RE: Units 1-2 & Basement Courtletts House, 38 King Street, West Manchester.

DETAILS OF EXISTING ENTRANCE

EXISTING GROUND FLOOR DETAIL AT ENTRANCE

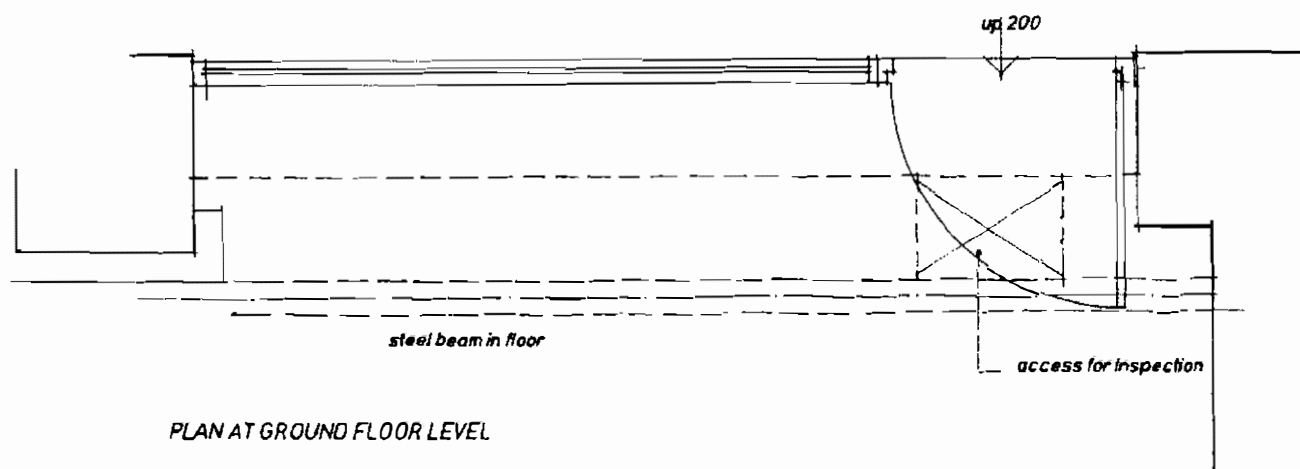
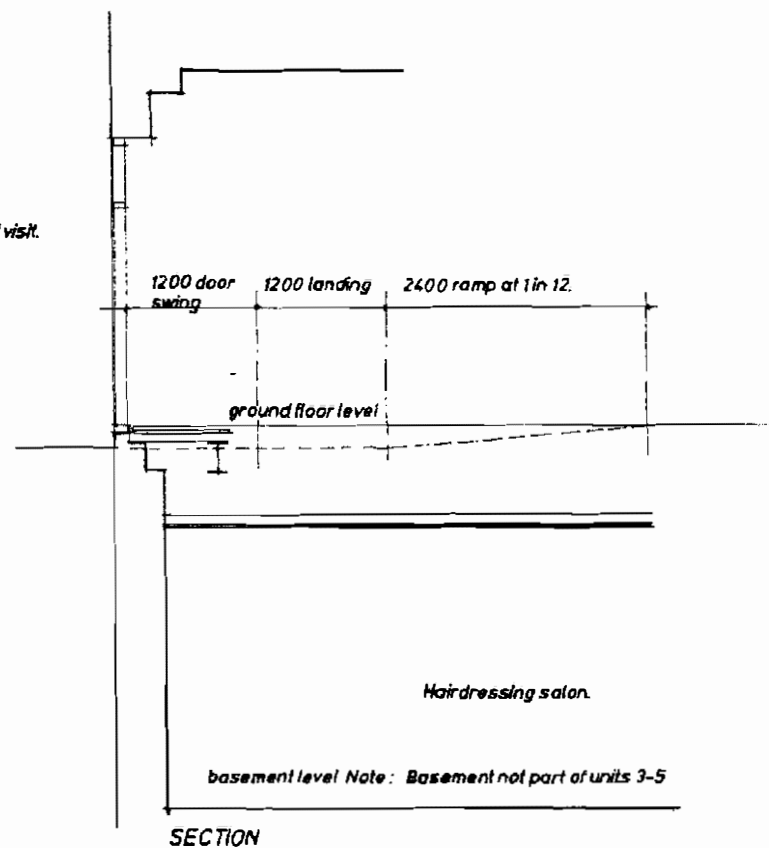
The ground floor is 200mm higher than the outside pavement level. A section of the ground floor was removed to expose the structure below. We can confirm that the ground floor consists of 2 layers of floor boarding on 50mm deep joists that bear onto a 305mm deep steel beam x 150mm wide.

The steel beam appears to span approx 4.0M and supports the ground floor only. However from our limited inspection it may be determined that the beam in question may be integral to the structure and provide some support to the front elevation and act as a tie beam.

To achieve the level access, a ground floor section of floor 200mm deep x 120mm wide x 4800mm must be removed.

Due to the depth of the existing ground floor covering being 140mm, approx 60mm must be removed from the steel beam. We have enclosed a drawing identifying the existing structure and the problems caused by the proposed works.

Removing part of the beam will reduce the section properties and strengthening would be required as one of the below options.

- A) Additional steelwork bolted/welded alongside or an additional steel beam under the existing reduced section - within the ceiling void above the staff room basement area.
- B) Removing the section of the steel beam to facilitate the ramp at ground floor would require additional vertical supports in the form of either steel columns/ brick piers. Both would require new foundations once we confirmed the makeup of the basement floor slab.

In general to summarise we can confirm there may be a structural engineering solution for the proposal, but we are strongly of the opinion it is not achievable for the reasons outlined above.
